MU2G4A041-R module Engineering Change Notice

ECN 02 003		
ECN No.	Date	Ву

FREESYSTEMS			2219M2	29 ECN	
		Document No.	ECN_02_003	1	Page 1 of 3
Released Document		Created By	Siew CK		E
Company Confidential		Approved By	Chan CO		der
		Date	23 rd Oct 2012	Revisio	on 1.0

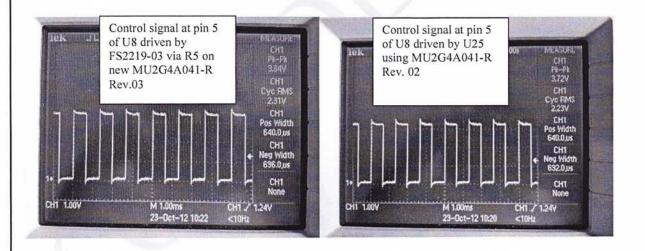
This ECN is to inform that new MU2G4A041-R, Rev. 03 module remove the extra inverter logic, U25 and replace with R5 zero Ohm resistor as show below

New FS2219-03 has absorbed the function of inverter into the IC to streamline the design

There is no functional or RF performance change due to this ECN and will not impact on the FCC qualification, FCC part 15.247 specifically for RF radiation standard of a product

The new chip component is compatible. The new chip has the same basic function as the old chip, and No change in radio parameters has occurred.
